RESOLUTION NO. 126-2025

A Resolution Approving a Major Modification to the Planned Residential Development for Application No. 25OLMT-DEV00002 (Valore Properties, Inc.)

Subject: Comment on Major Modification Trustee Public Hearing

Re: Sanctuary and Preserve Phase 2B and 5 – Conditions for Approval

PROPOSED
LANDSCAPE PLAN
C-003

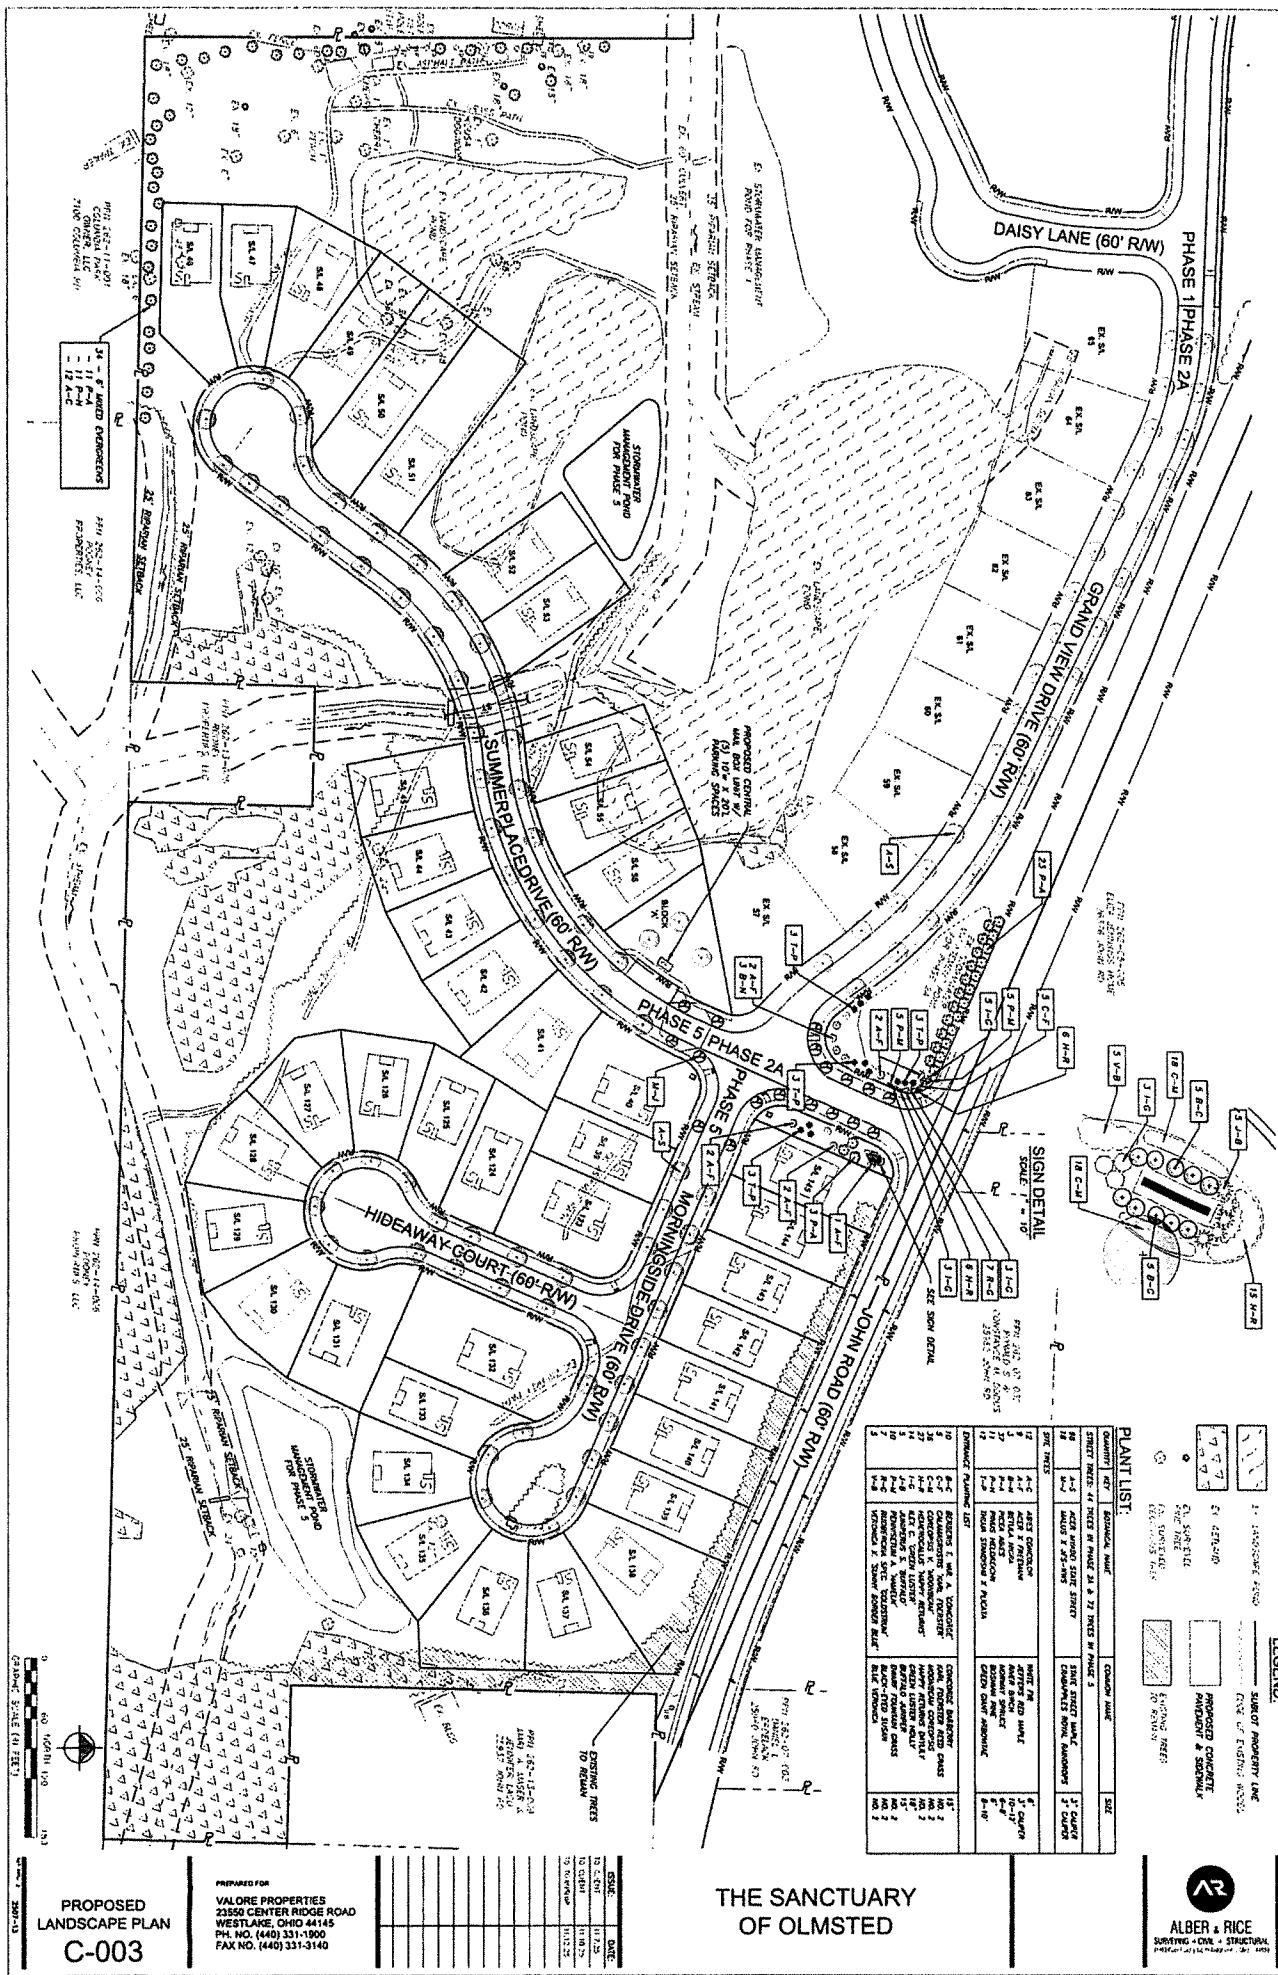
4. The approval does not include any landscaping changes identified in Phase 2A.
5. The approval includes application documents with signature date of 10-24-25, sheet C-003 dated 11/12/25, sheet C-004 dated 11/10/25, C-005 dated 12/1/25, and traffic impact analysis dated 11/7/25.

PHASE 5
OVERALL
DIMENSION PLAN
C-004

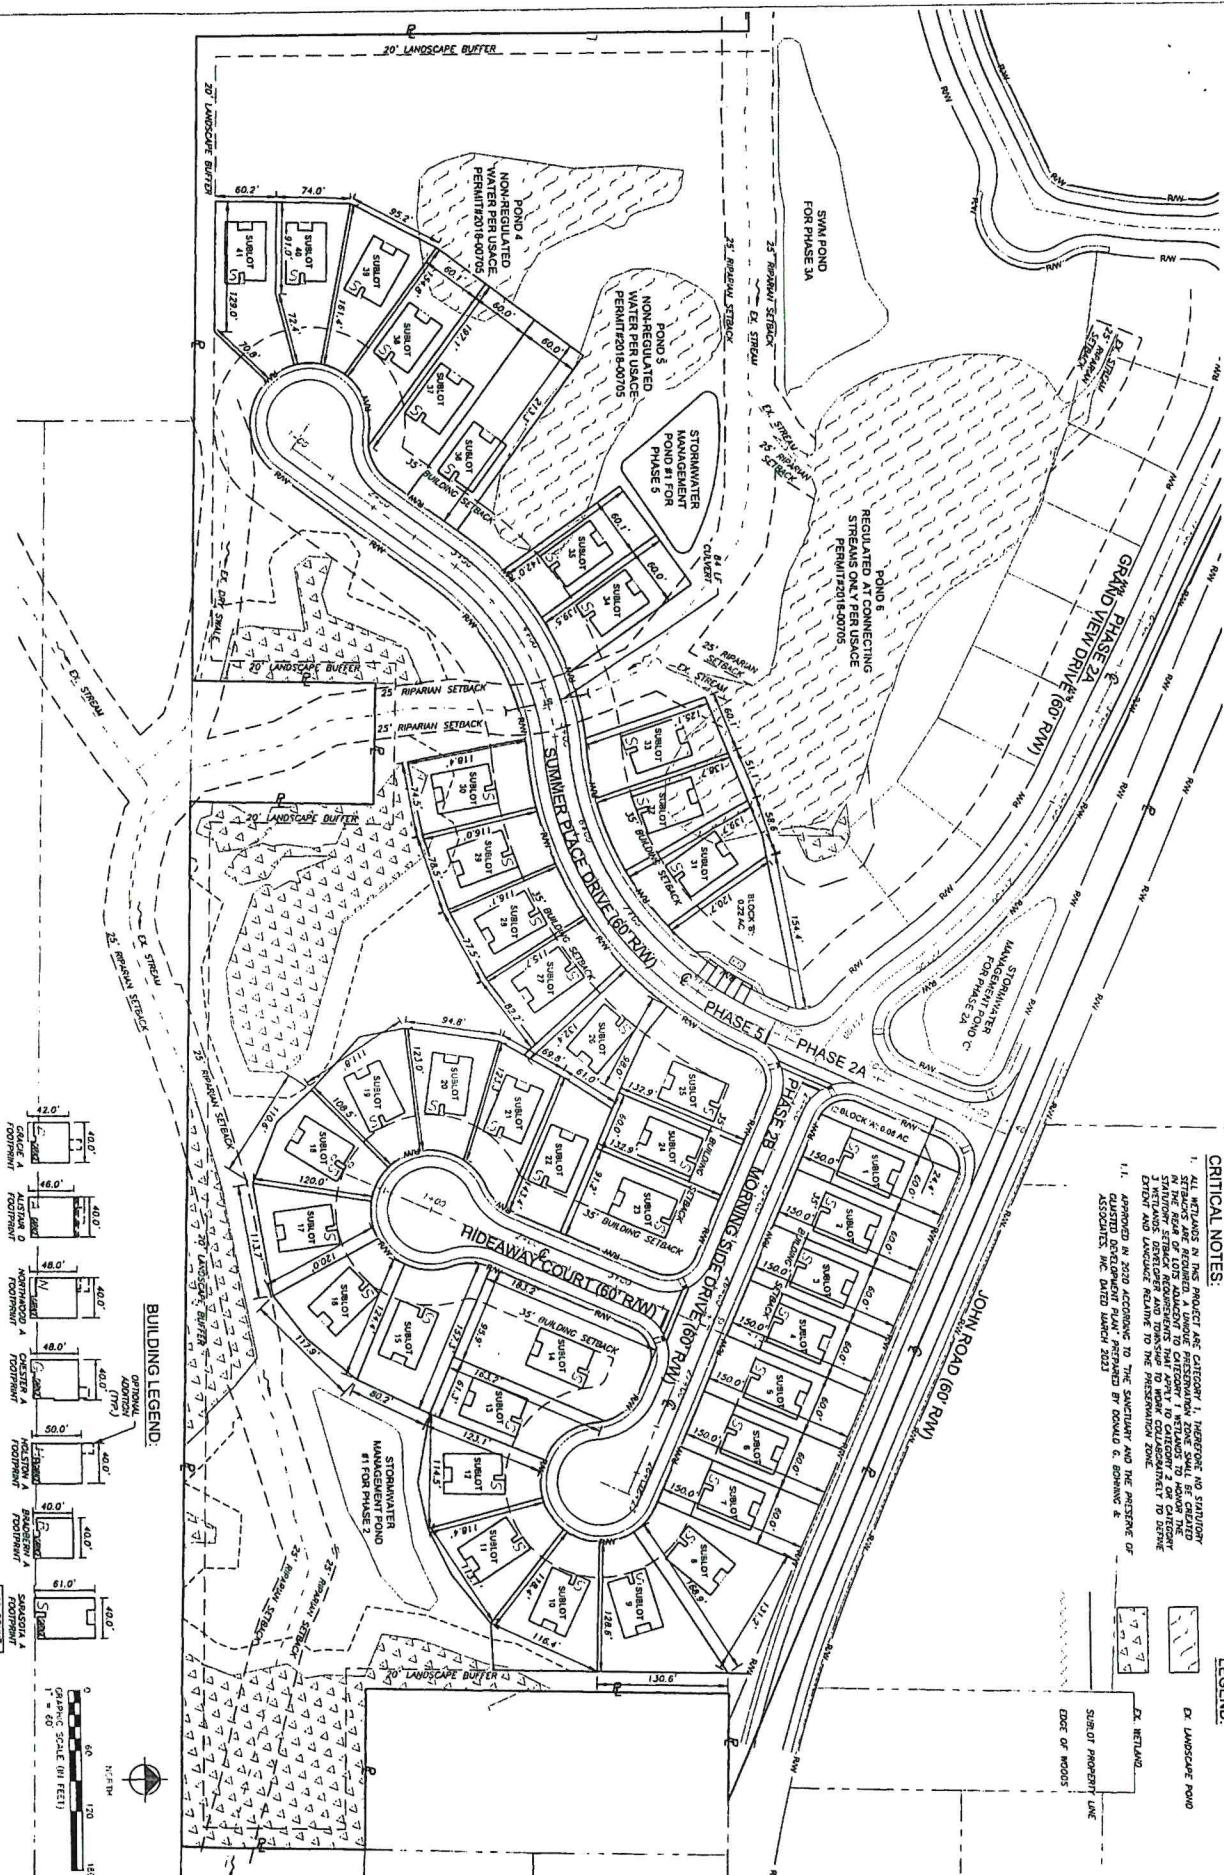
3. The approval of this major modification shall be conditioned upon the developer reducing the length of the southernmost cul-de-sac to meet Cuyahoga County Land Development Regulations or obtain a modification approval from the Cuyahoga County Planning Commission.

- a. The extension of the southernmost cul-de-sac shall not exceed 800 feet in length in accordance with **Section 106.3 (A)(3)(b)** of the Cuyahoga County Land Development Regulations (2007/2010).
